### 3/4.2 POWER DISTRIBUTION LIMITS

#### 3/4.2.1 AVERAGE PLANAR LINEAR HEAT GENERATION RATE

Figure 3.2.1-4

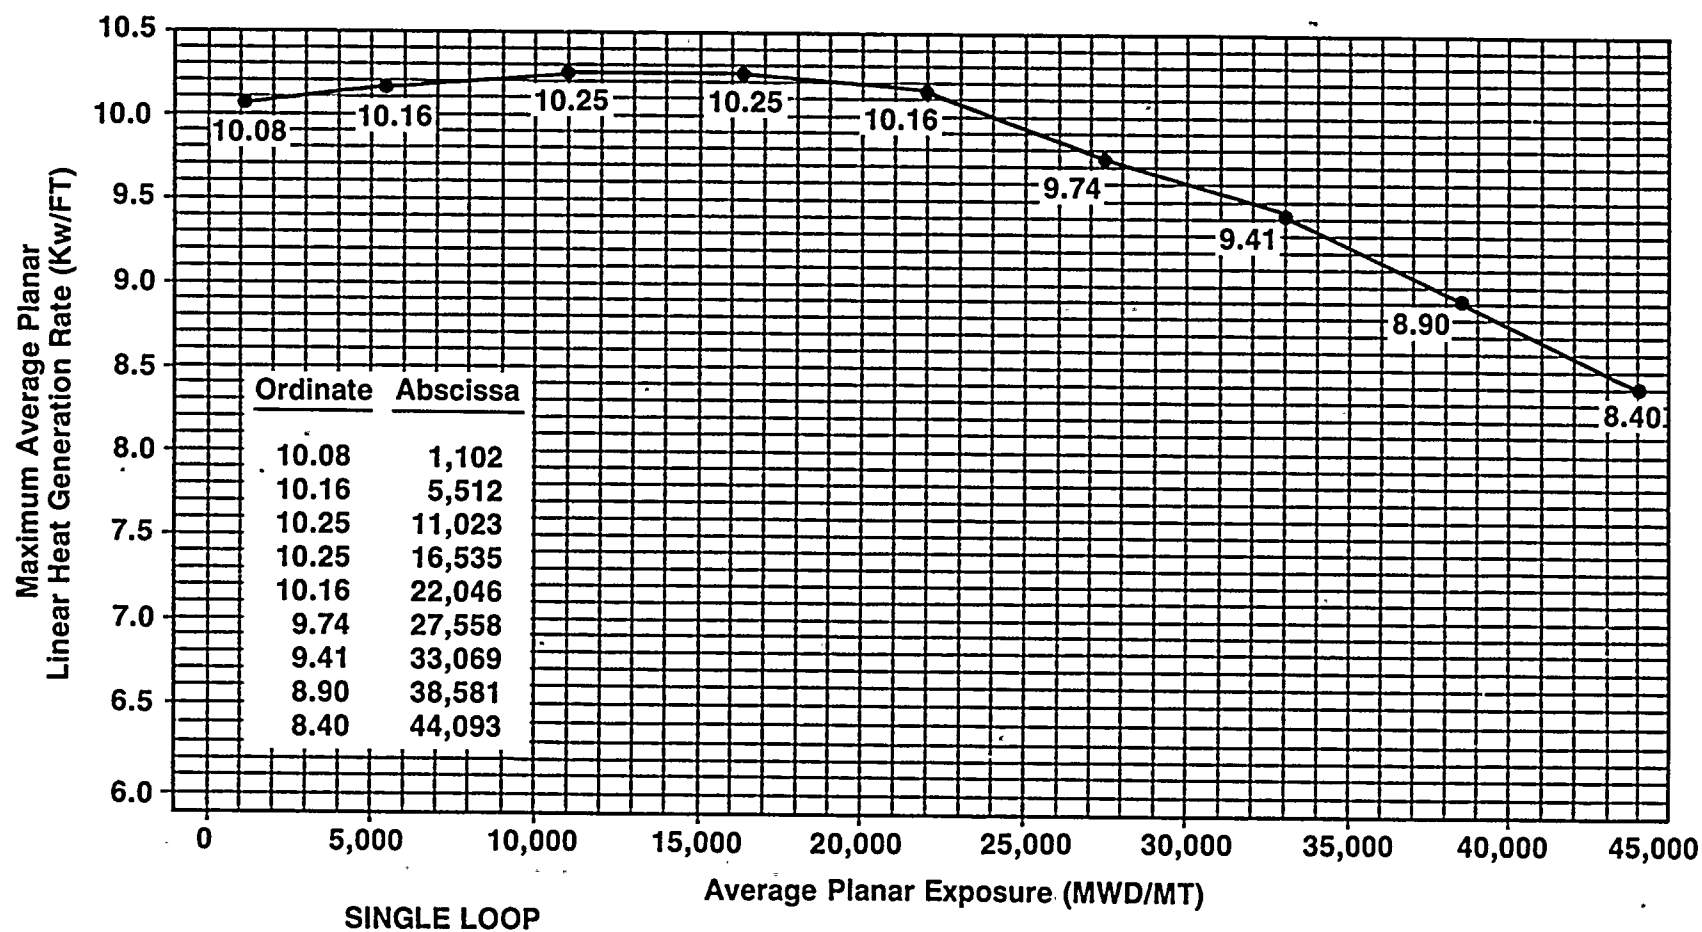
With an APLHGR exceeding the <sup>applicable</sup> limits of Figure 3.2.1-1, 3.2.1-2, ~~or~~ 3.2.1-3, 3.2.1-4, 3.2.1-5, initiate corrective action within 15 minutes and restore APLHGR to within the required limits within 2 hours or reduce THERMAL POWER to less than 25% of RATED THERMAL POWER within the next 4 hours. <sup>or 3.2.1-6</sup>

4.2.1 All APLHGRs shall be verified to be equal to or less than the limits determined from Figures 3.2.1-1, 3.2.1-2, ~~and~~ 3.2.1-3, 3.2.1-4, 3.2.1-5, and 3.2.1-6.
